PROGRESS REPORT

Independent Review of Implementation of Revised Seismic Design Criteria Hanford Waste Treatment and Immobilization Plant (WTP)

Revision D

U.S. Army Corps of Engineers
Walla Walla District

**Response to SM-5 and SM-29
C. J. Costantino**

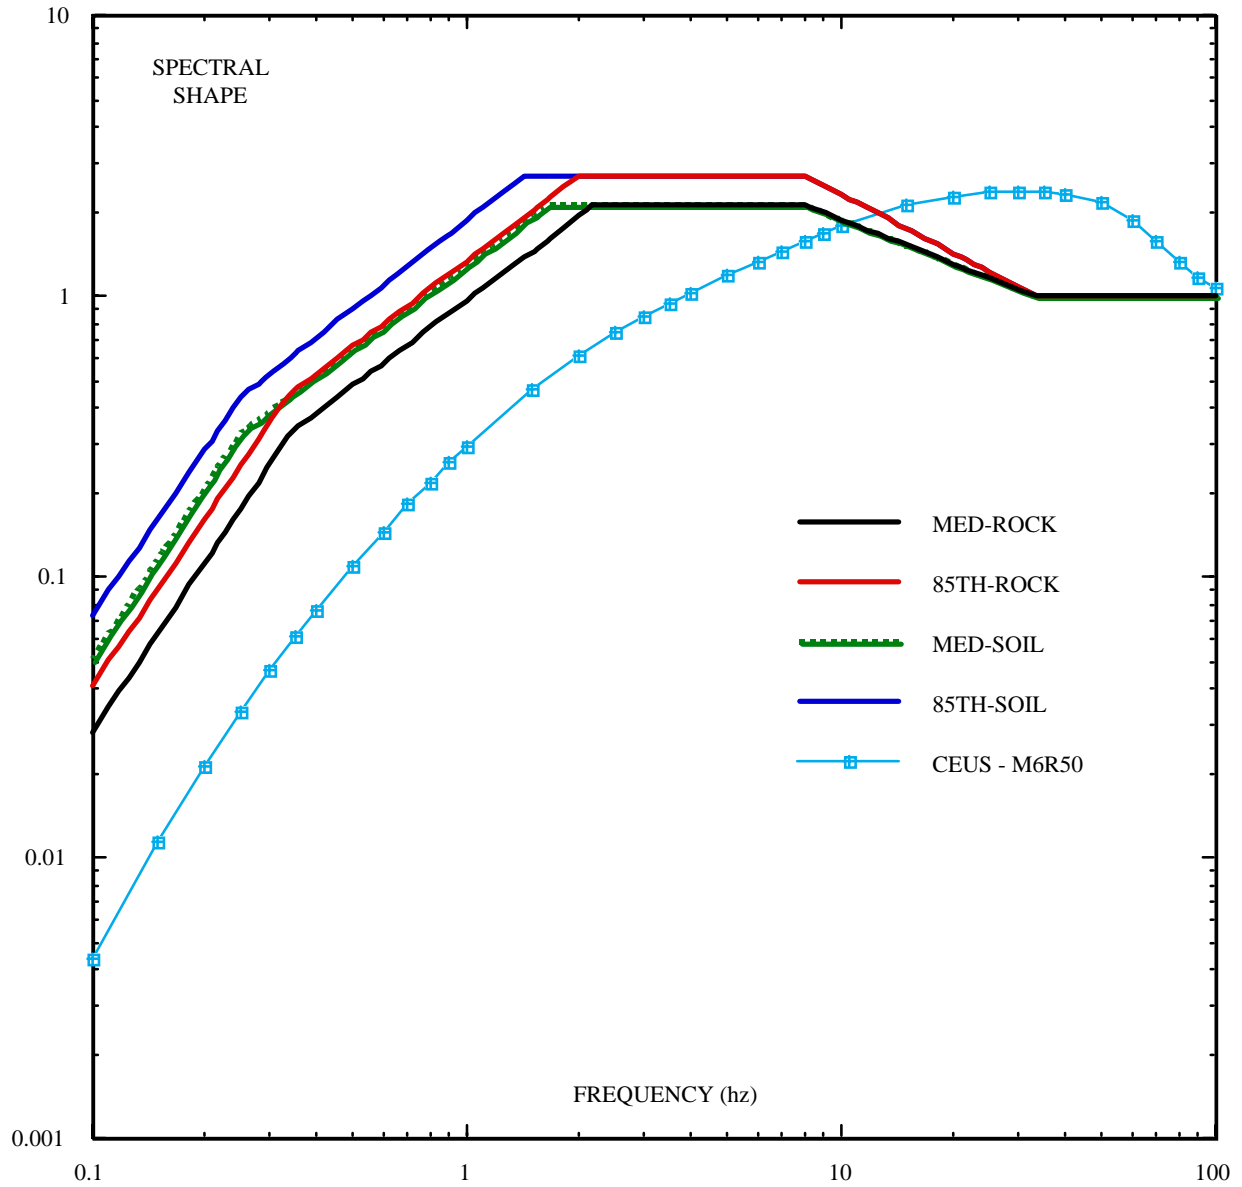
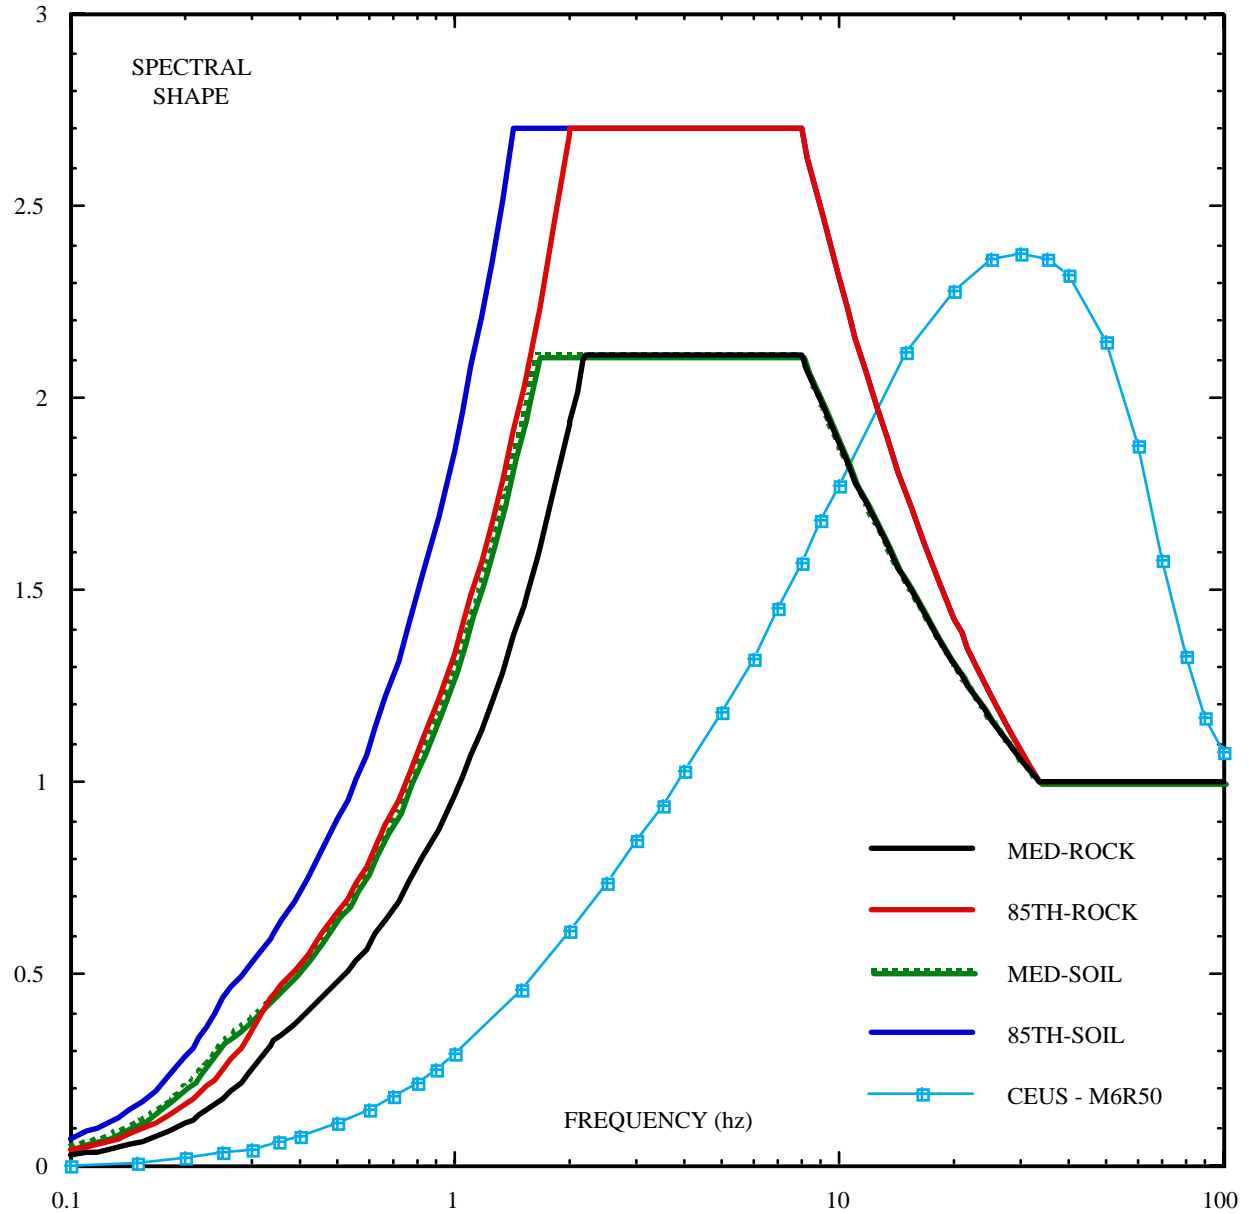
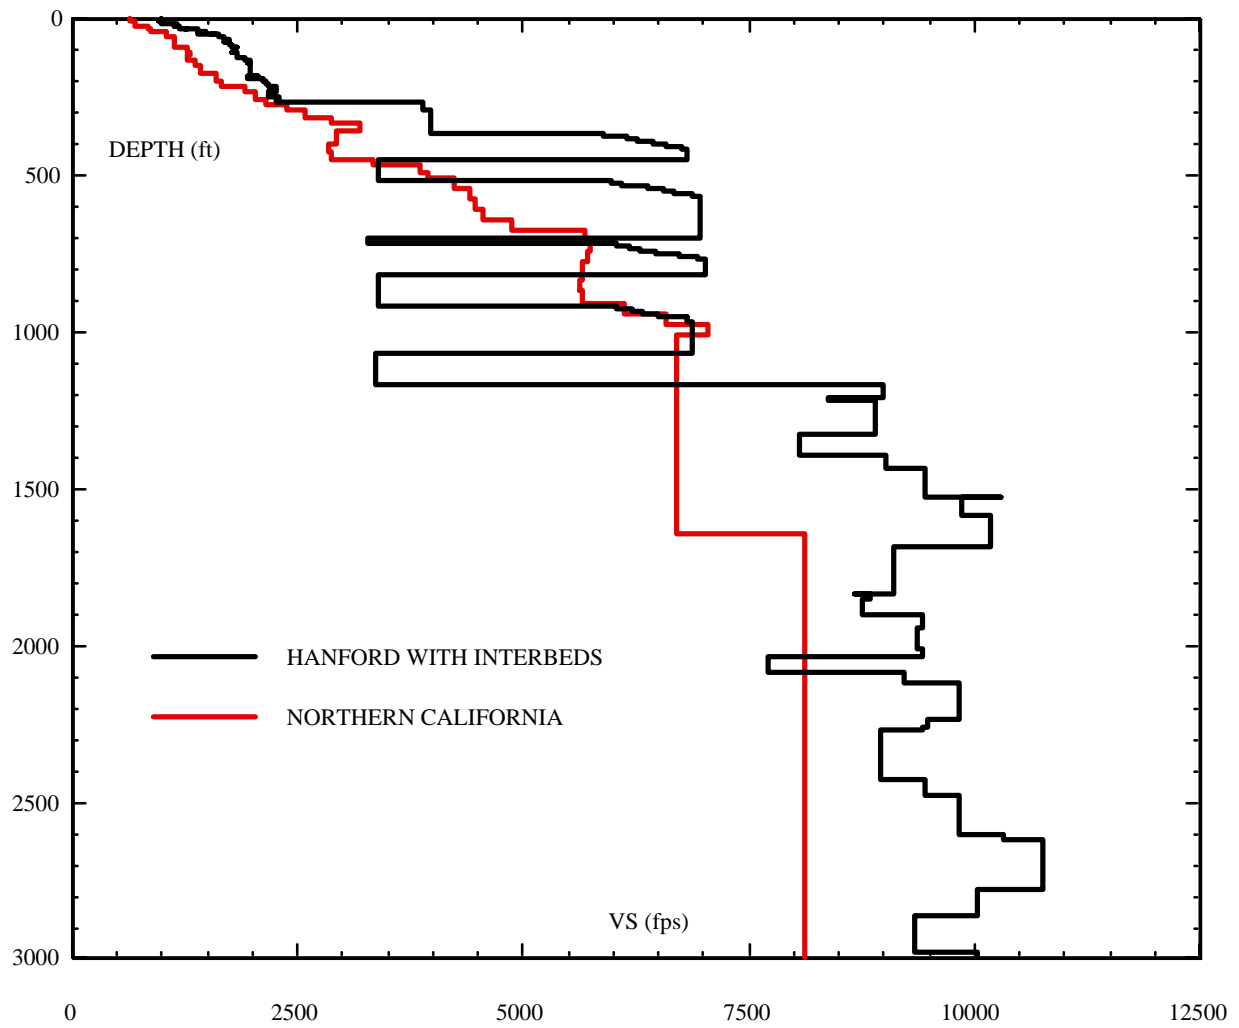
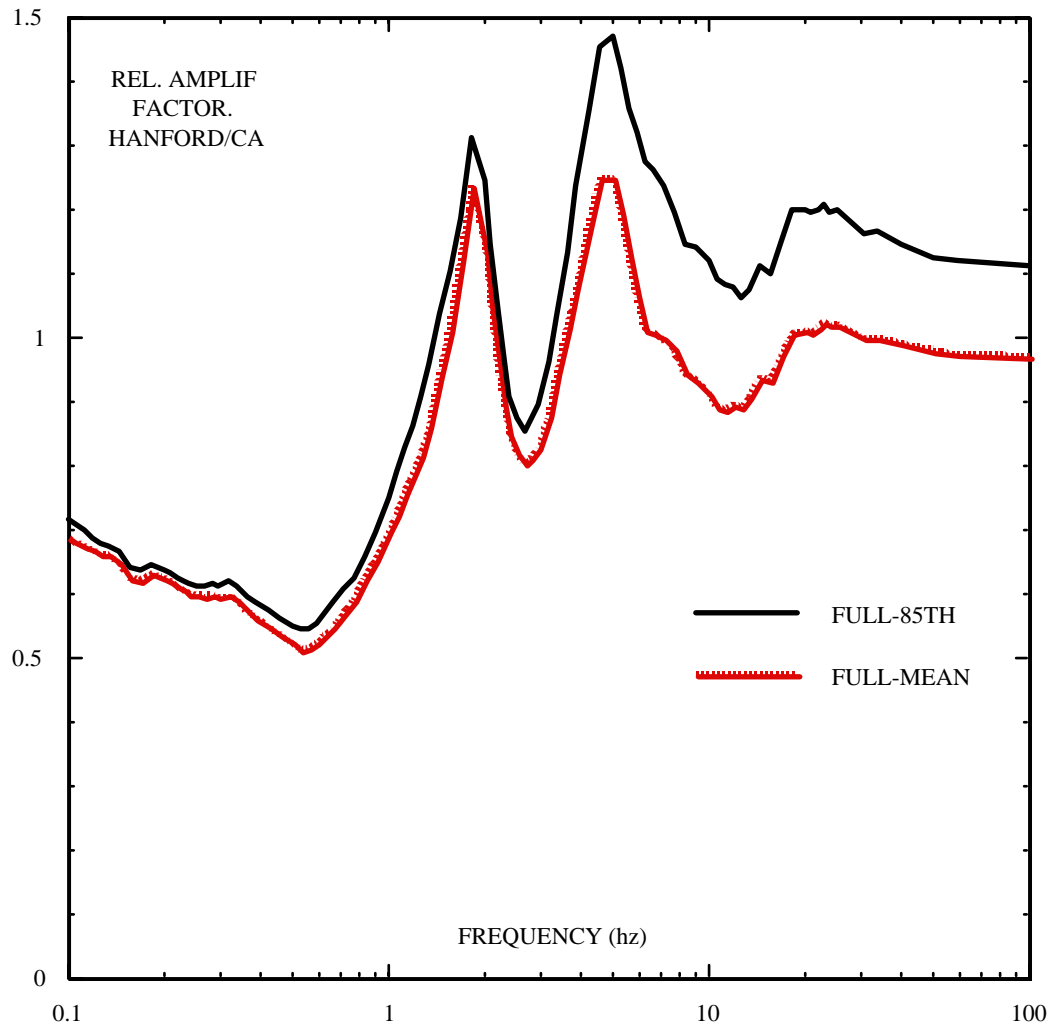
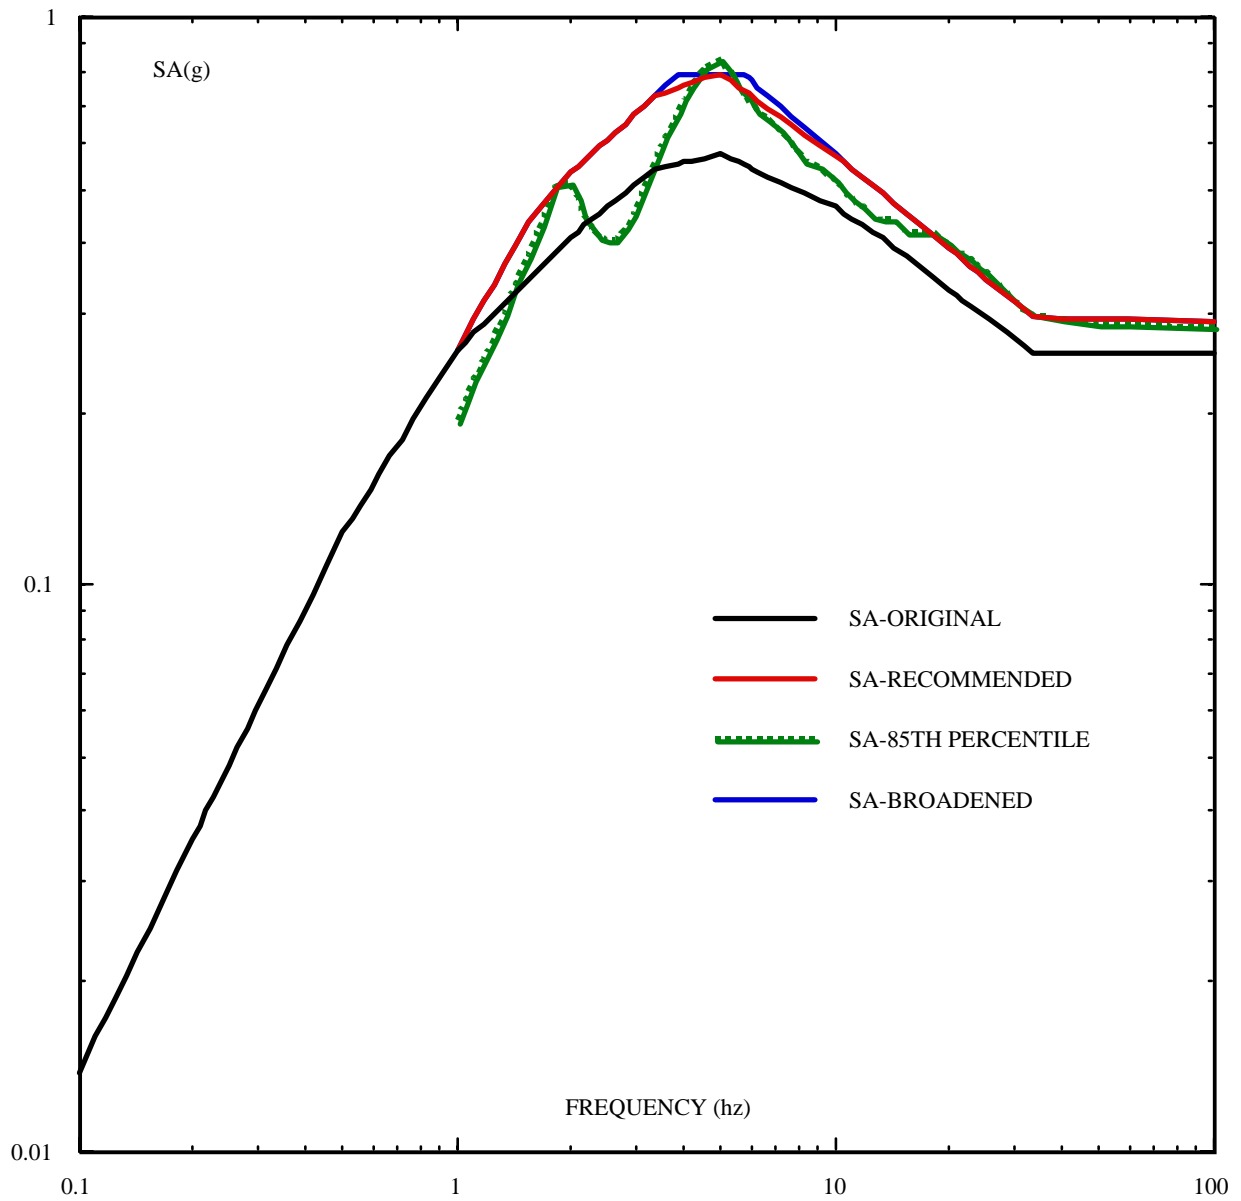
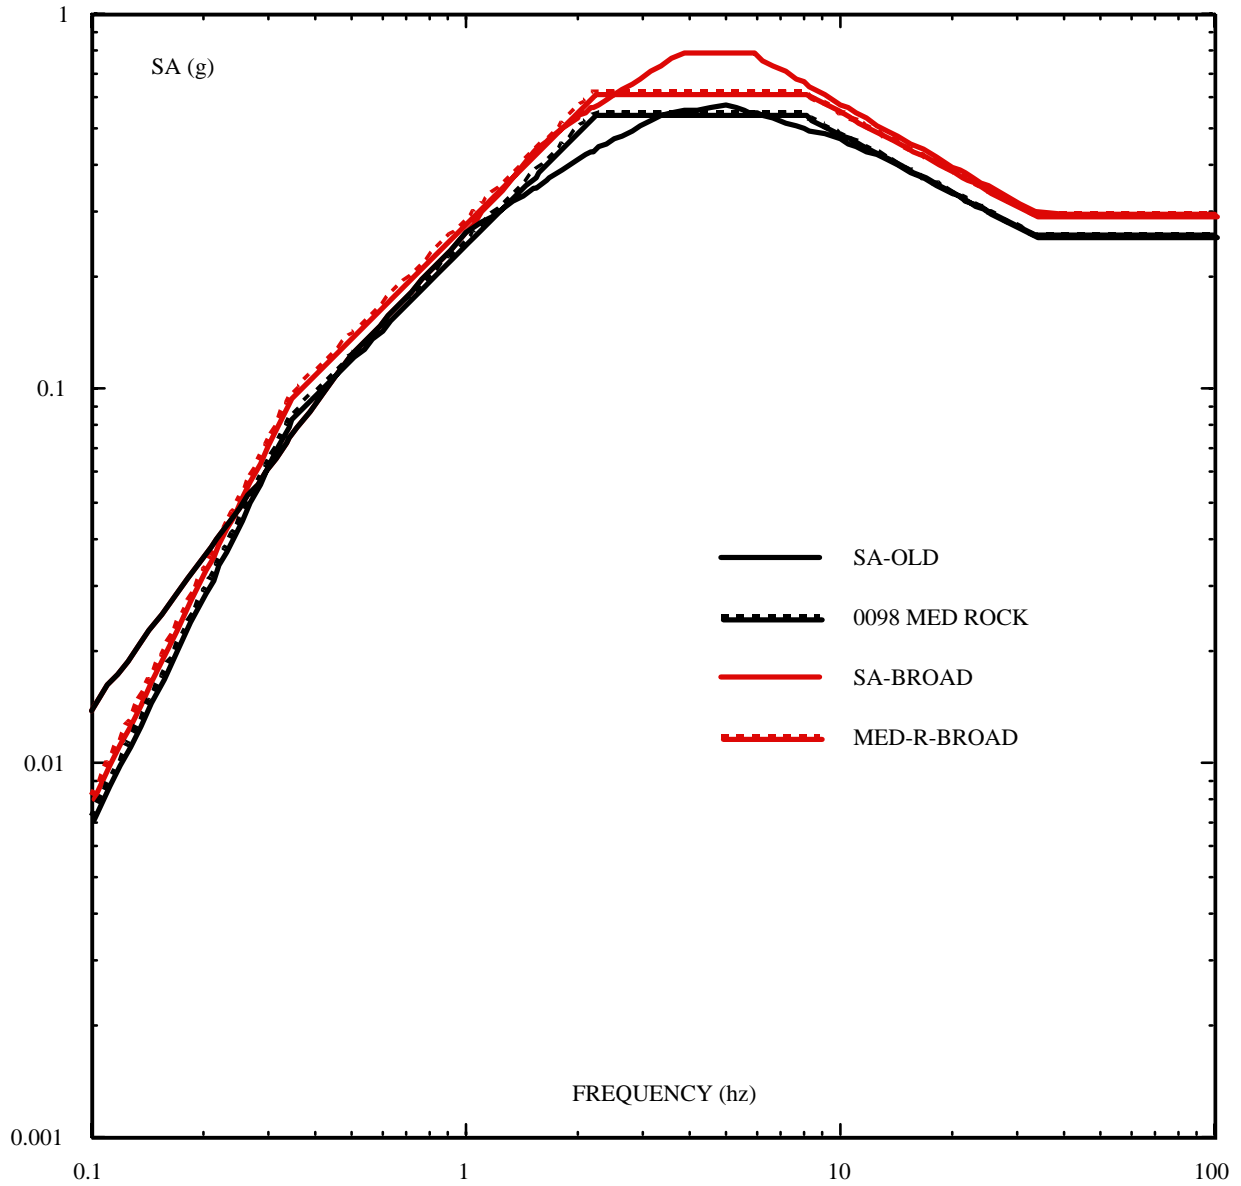
SM-29	24590-WTP-DC-ST-04-001, Rev. 3, Seismic Analysis and Design Criteria	Reviewer: James J. Johnson Figures 1 and 2 (Ref. 1) and Slides 17 and 18 (Ref. 2) present the	DOE-ORP 1 st Response: Carl Costantino , see attached Response to SM-5 and SM-29.	Open 1 st Follow-up: An additional review during the week of 27

Figure 1 shows both median and 85th percentile spectral shapes associated with the 0098 spectra recommended for either rock or soil sites. Appended to the plot is a spectral shape currently being recommended by both NRC and DOE for CEUS hard rock sites. These eastern shapes are much more skewed to high frequencies and clearly are very much steeper in the frequency ranges of general structural interest. Figure 2 presents the same data plotted on a log-linear plot. The issue of peakedness of these shapes is clearly subjective. The important issue to keep in mind is that the design spectra must be developed to capture the primary responses associated with the potential effects of site characteristics. The use of very broad-banded spectra, such as RG 1.60 shapes, are no longer considered appropriate for design since they clearly do not generally capture the potential important effects of site conditions. The comment on steepness of slopes of design surface spectra is not one that is currently considered in guidance documents prepared for NRC, DOE or ASCE. The general tone of these documents is to generate spectra appropriate for given sites, capturing the effects of these characteristics in a suitably conservative fashion.

Figure 3 presents a comparison of the low strain shear wave velocity profile associated with a Northern California (NCA) generic soil site with the best estimate profile at the WTP site. The existence of stiffer rock at depth as well as stiffer sediments in the upper 350' of the WTP profile indicated a surface response that would be expected to be significantly higher than at the generic site. Similar conclusions were drawn for comparison with the Southern California (SCA) generic profile. In addition, the more linear sediment properties anticipated for the WTP sediments as compared to the CA generic models indicated that site amplification would be larger at WTP than at the generic sites. An issue of significant uncertainty concerned the impact of the properties and detailed configuration of the basalt/interbeds on site amplification.

As can be noted in Figure 4, there is no significant frequency shift between the mean relative amplification factors, Hanford/CA, as compared with the 85th percentile response. In addition, the relative amplification factor around 2 Hz is about the same, mean to 85th, while the ratio is larger at about 5 Hz and above. This characteristic is an indicator of the relatively linear response characteristics of the site; that is, no significant nonlinear material behavior was noted in these response calculations. One of the large contributors to the range of responses around 5 Hz was due to the uncertainty in characteristics of the basalt/interbed sequence. With better definition of these properties, the recommended relative amplification factor that may be used with confidence may in fact be lower.

Figure 5 presents a comparison of the original site-specific surface response spectrum developed in the original hazard analysis with the current recommendation. The process followed was to apply the 85th relative amplification factor computed from the logic tree analysis to the original design spectrum and then smooth over frequency gaps in the resulting response spectrum. This spectrum is labeled "SA-Recommended" in Figure 5. The value at the peak is somewhat lower than that resulting from the 85th relative amplification. The spectrum at the peak was then broadened somewhat at the crown to capture typical effects of probabilistic spectra calculations. The spectrum labeled "SA-Broadened" is then considered a conservative estimate of the MEAN surface spectrum that can be used for design. The results determined from the

Finally, Figure 6 presents a comparison of the various spectra discussed in Figure 5 with the generic NUREG shapes. The original spectral shape recommended for the site is compared with the median NUREG shape scaled to the same PGA and using V/A of 36 in/sec/g and AD/V^2 of 6. As can be seen, the spectra are comparable in the constant acceleration range, although the fit at low frequency can be improved by modifying the assumed parameters. A similar comparison is provided for the modified recommended spectrum and scaled to the revised PGA. The width of the spectrum is again very comparable to the NUREG shape indicating that the “peakedness” comment of the recommended spectrum is inappropriate. The amplification in the range between about 2.5 Hz and 8 Hz is greater than indicated by the NUREG shape due primarily to the differences in characteristics between the CA generic profiles and the WTP site-specific profile.
